ADDENDUM NUMBER: One (1)

TITLE: 1411804646 096-04 Oakridge WTP – HSP Replacement Project

JEA RFP NUMBER: 1411804646

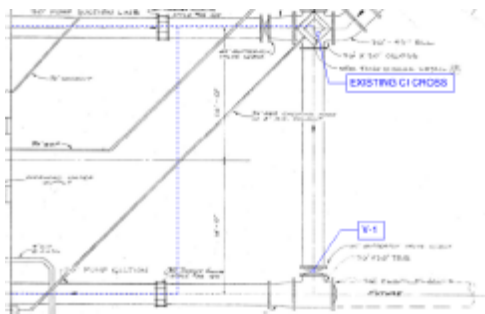
- 2) **Requesting Clarification:** Per sheet 10M00 – Drainage Improvements, note 1 states that some items have been removed or modified. Please confirm valve V-1 and the existing 36”x30” cross shown below are currently installed per sheet 10M100. If yes, please also confirm valve V-1 is operable.

Clarification: The 36” x 30” cross does not exist, there is now a Tee in that location as indicated by drawing 00DC01. Valve V-1 exists but does not function. Based upon field investigation, it was concluded that none of the suction side valves are operable. Contractor shall implement means and methods to maintain service and complete construction in accordance with phasing notes in specifications and per the plans.
